## Architectural Evaluation Report

VA Project No.: 11-14

Project Name: City of Winnipeg Machray Park Redevelopment

Re: Machray Park Redevelopment  
Architectural Evaluation of existing Wading Pool change room, washroom and mechanical building.

WASHROOM INTERIOR

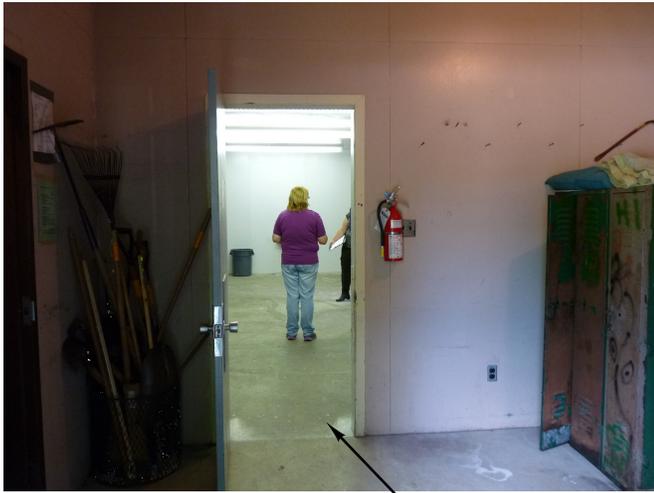
**TOILET PARTITIONS:**

- Replace wood toilet partitions with solid plastic toilet partitions

EXISTING STORAGE/STAFF ROOM

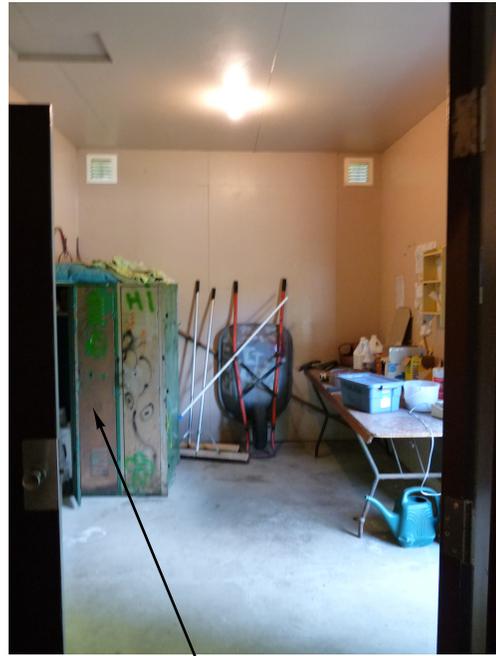
EXISTING 32"  
DOOR

STAFF LOCKERS:  
- Replace existing lockers

EXISTING WADING POOL MECHANICAL ROOM

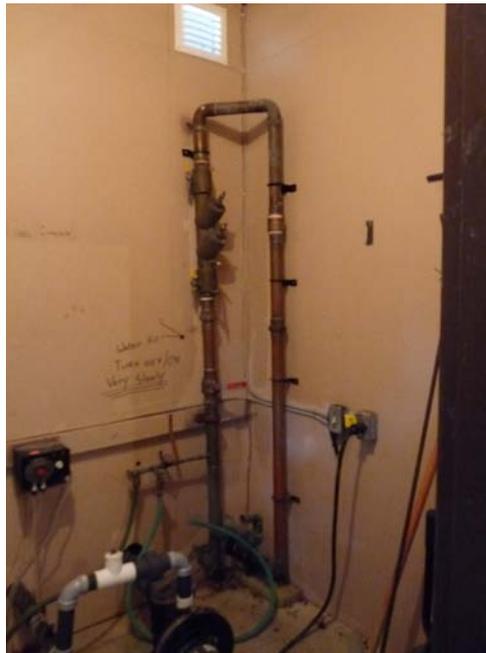
EXISTING 36" DOOR
